From: Kristen Kapelanski, AICP
Date: 7/10/2019
Re: **Rochester Hills Trio PUD (City File #18-016)**
PUD Concept Plan - Planning Review #7

From: Jason Boughton, AC, Engineering Utilities Coordinator
To: Kristen Kapelanski, AICP, Planning Manager
Date: July 9, 2019
Re: Rochester Hills Trio PUD, City File #18-016, Section 27
PUD Plan Review #7

From: William A. Cooke, Assistant Chief / Fire Marshal
To: Planning Department
Date: July 8, 2019
Re: Rochester Hills Trio PUD

CITY OF ROCHESTER HILLS				
STANDARD DETAIL FOR:				
Rochester Hills Truck 1				PREPARED BY DEPT. PUBLIC SERVICE DIV.
Truck Minimum Turning Radius				
DRAWN BY	FILE NAME	PLAN DATE	REV.	REV.
DS	FIRETRUCK1	2/26/01		
APPROVED BY:		SCALE: 1" = 20'	SHEET	
MARE MATON CITY TRAFFIC ENGINEER			1 OF 1

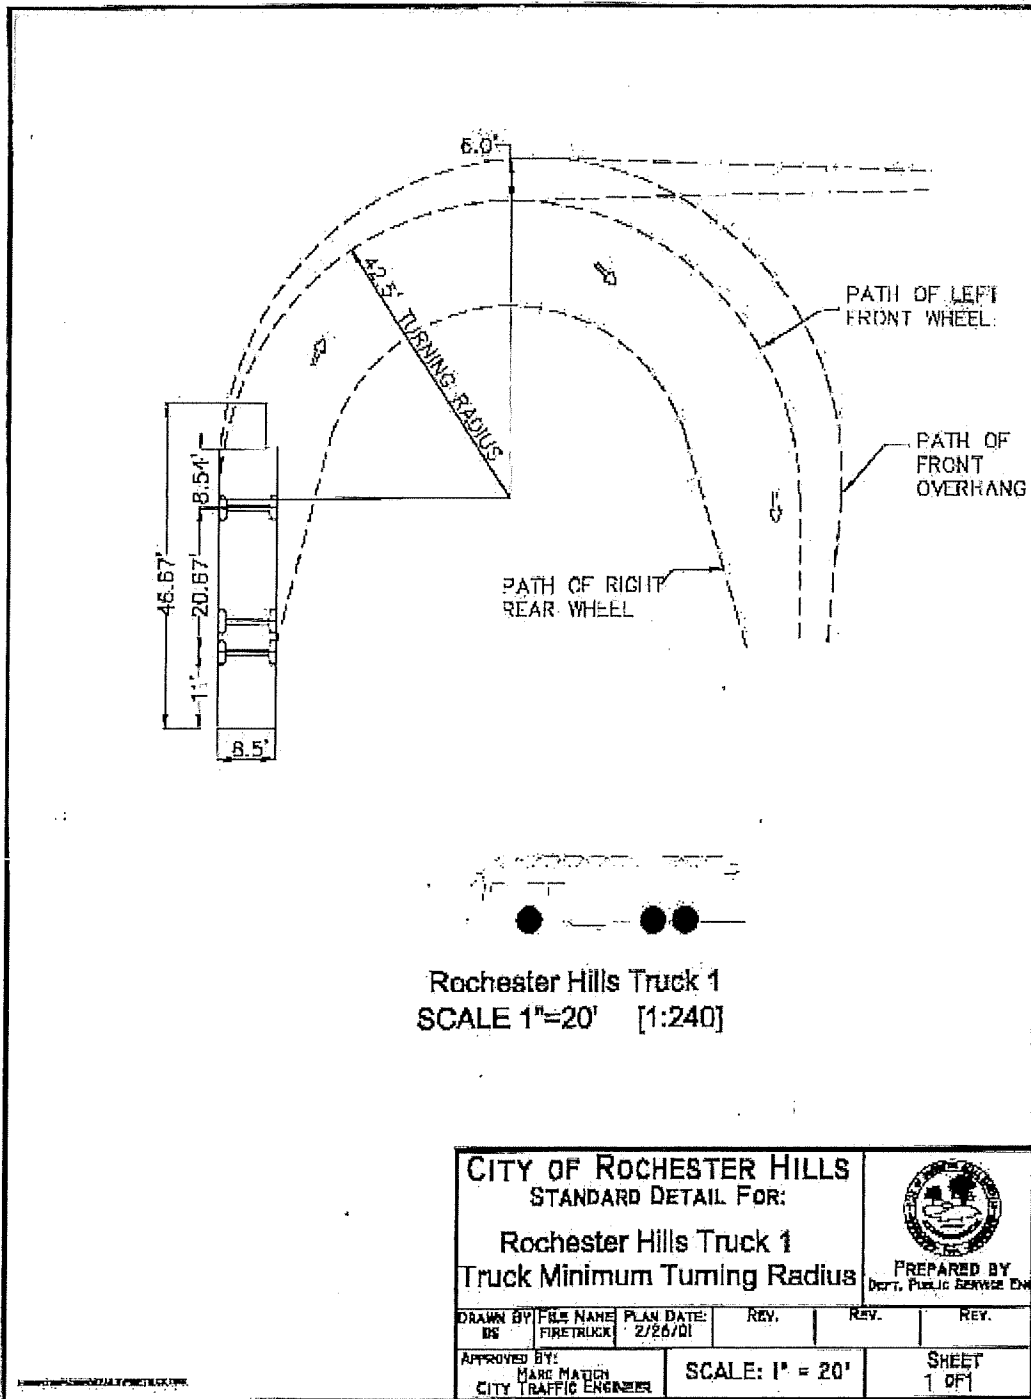
1. Please provide the fire truck overlay on sheet S100 so that the minimum fire truck radius requirements have been satisfied. Please pay special attention to the drive to the south of Building "A" since the site configuration has changed as well at the area east of Building "C" since the width of drives have changed. The minimum fire truck dimensions have been attached to this review for your use.
